SERVICE BULLETIN No. 92-012

Capstan Control D/A Converters

MODEL: Micro Lynx System Unit

Figure 2. Power Switch Diode Position

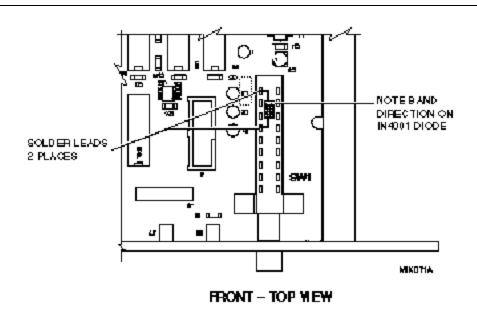
The modification is to add a 1N4001 diode between the +12V and +5V supplies so that the +5V supply will track the +12V supply on power up.

- 3. Turn the System Unit so that the front panel faces you and locate the Power switch.
- 4. Solder a 1N4001 diode between the power switch terminals as shown in Figure 2. Be careful to correctly position the diode so that the white banded end of the diode is pointing towards the rear of the System Unit.
